Addendum 5

December 2, 2022

SUCF 081058-00 Upgrade Elevators - Campus Wide at SUNY New Paltz, 1 Hawk Dr.
New Paltz, NY 12561

Prepared by MDSzerbaty Associates 307 Seventh Avenue, Suite 1501, New York, NY 10001 and
IAQ Systems Inc., 555 Eighth Avenue, Suite 1502, New York, NY 10018

2 HVAC - STUDENT UNION BUILDING PENTHOUSE PART PLAN
 SUB-M101 SCALE: 1/4" = 1'-0"

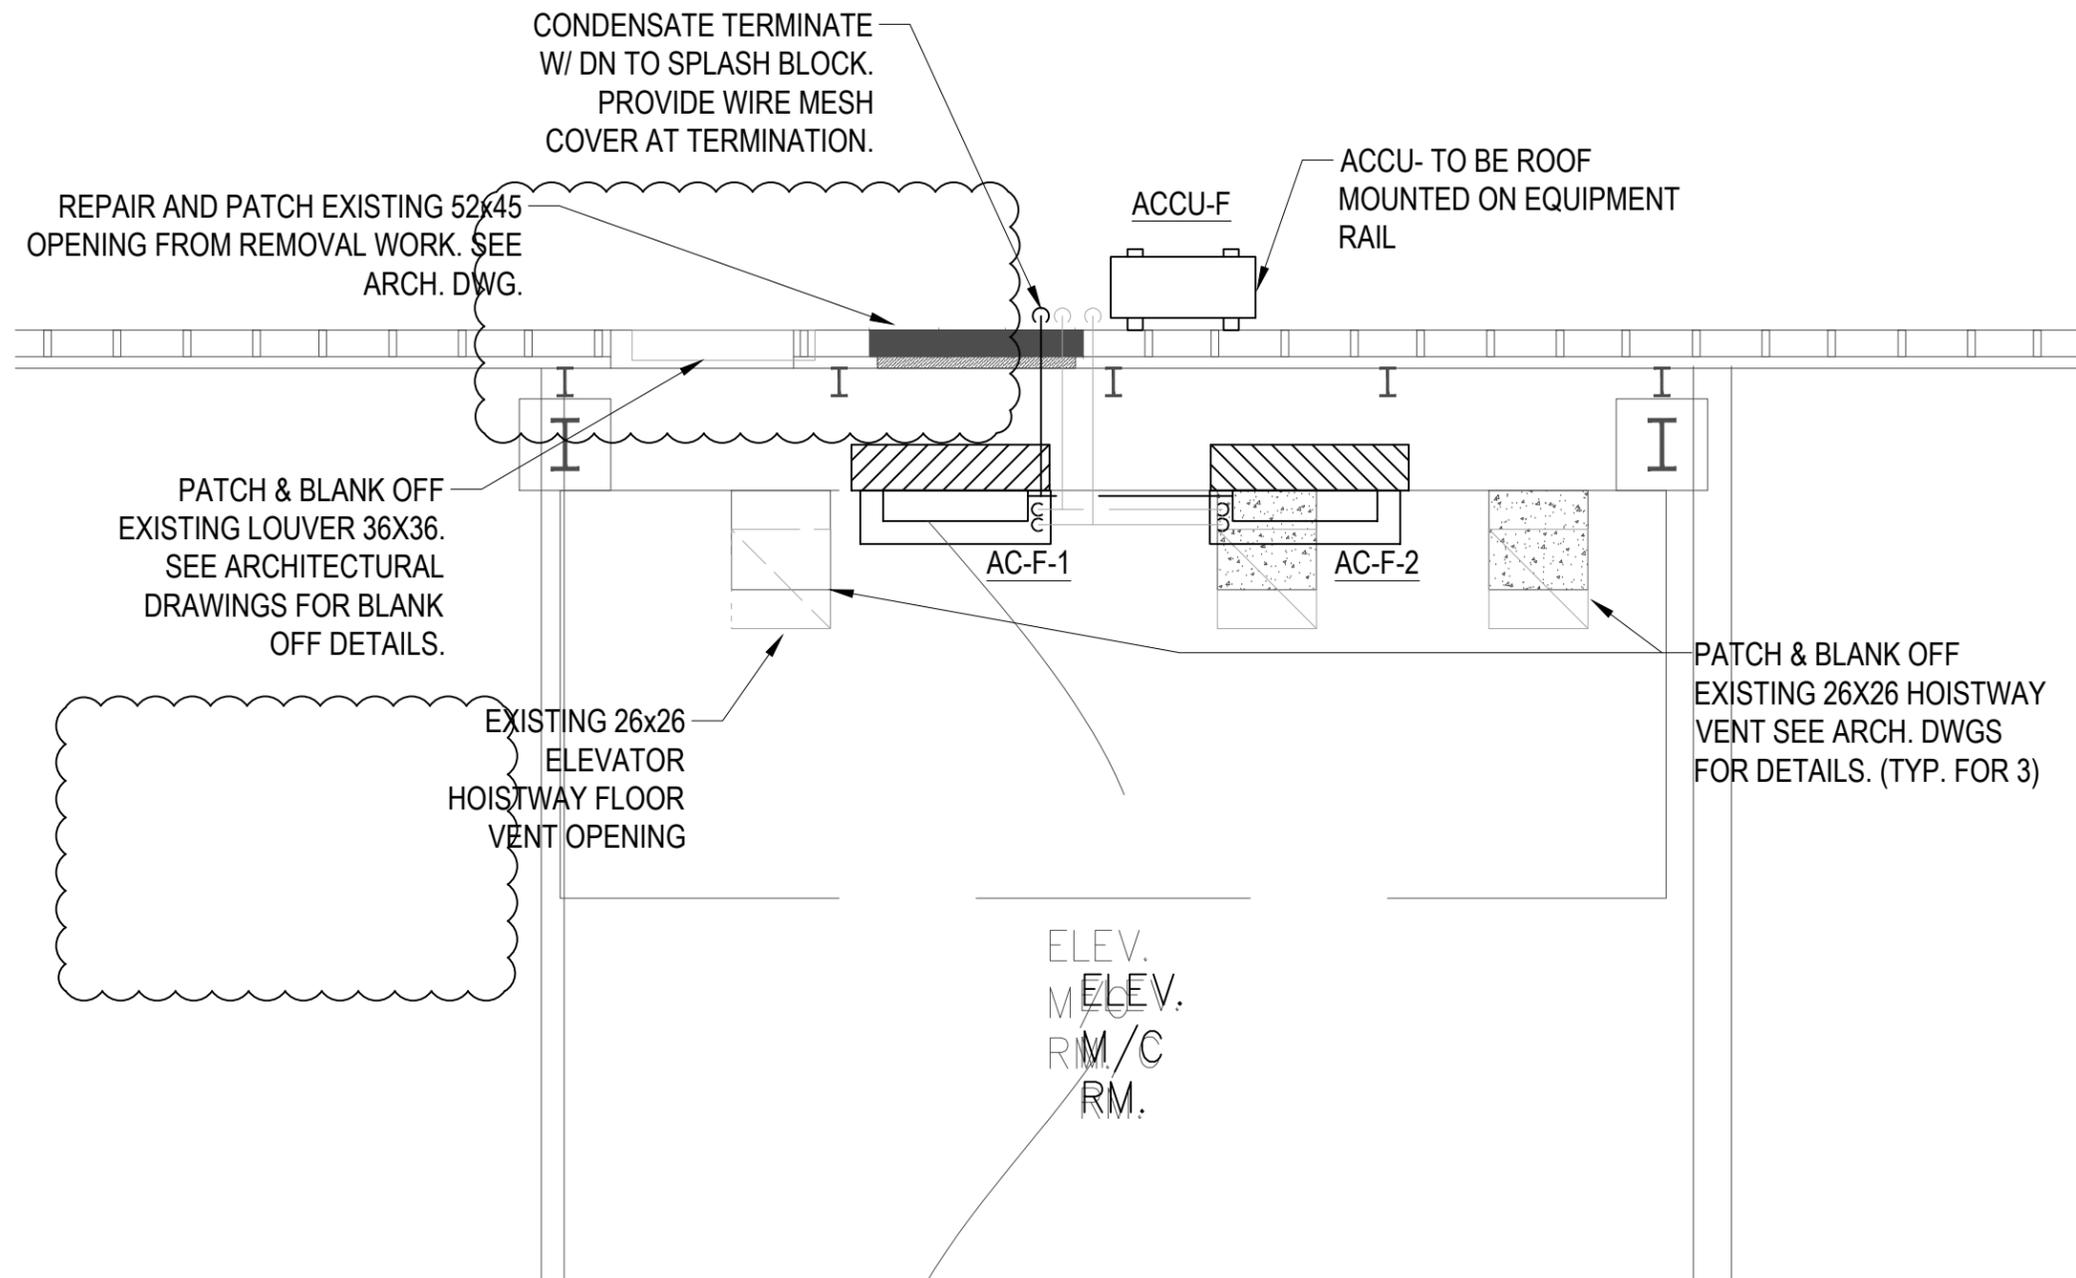
Revise drawing 2 as shown on attachment 42.

13 HVAC DETAILS SHEET 2 OF 2
M502 SCALE: 1/4" = 1'-0"

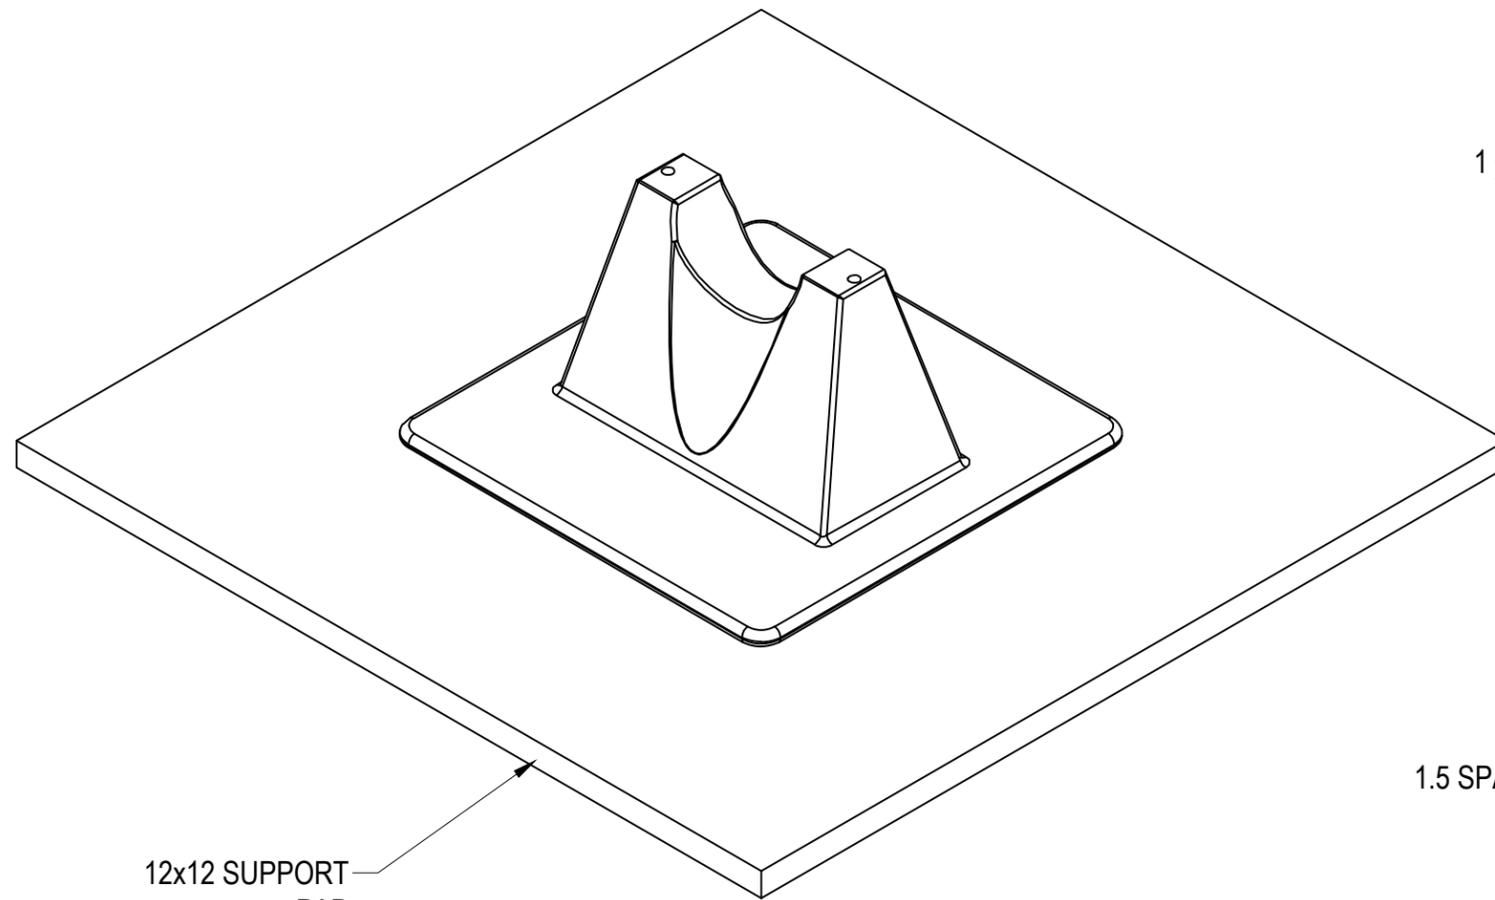
Revise drawing 13 as shown on attachment 43.

1. SUPPORT SHALL BE OPTIMIZED TO CARRY UP TO A 1-1/2" PIPE.
2. MAXIMUM PIPE OD FOR THE SUPPORT SHALL BE 1.9"
3. PIPE CLEARANCE SHALL BE 2"
4. 1.5 SPACER ACCESSORY SHALL ADD AN ADDITIONAL 1-1/2" OF HEIGHT PER SPACER. UP TO 2 SPACERS SHALL BE USED.
5. MAXIMUM LOAD SHALL BE 72 LBS. BASED ON 3.0 PSI TO THE ROOF DECK. EVEN LOAD REQUIRED.
6. UNIT WEIGHT: 0.34 LBS.
7. 48 PER CASE (22 LBS.)
8. SPACING SHALL NOT EXCEED 7' CENTERS DEPENDING UPON THE LOAD.

1. HAB EMERGENCY POWER PANEL

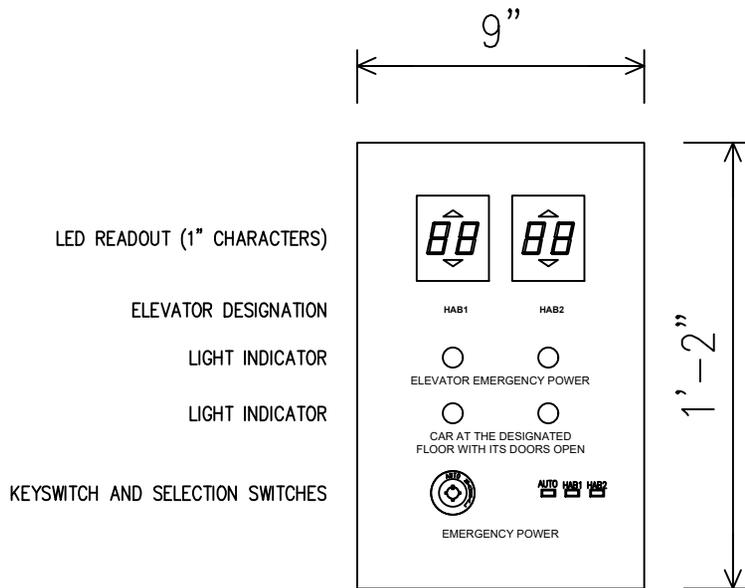
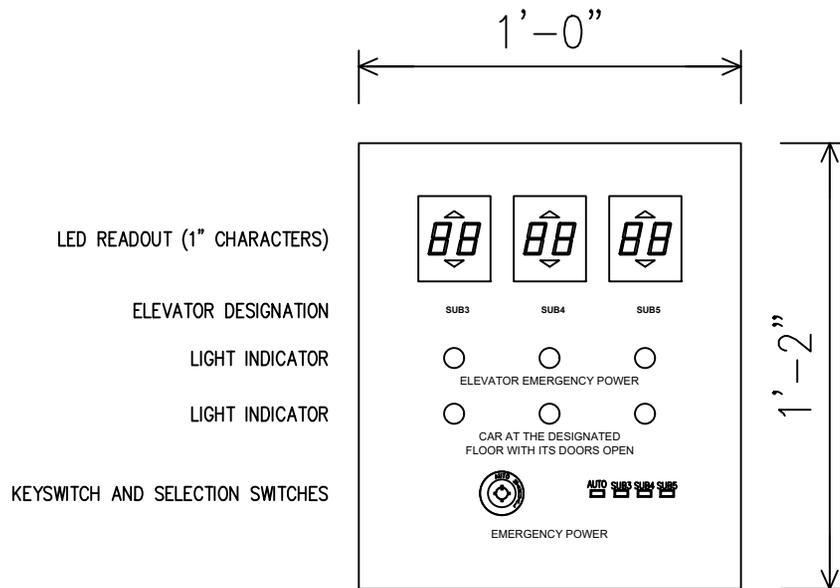
Add drawings 1 and 2 on attachment 46.

Add drawing 3 on attachment 46.
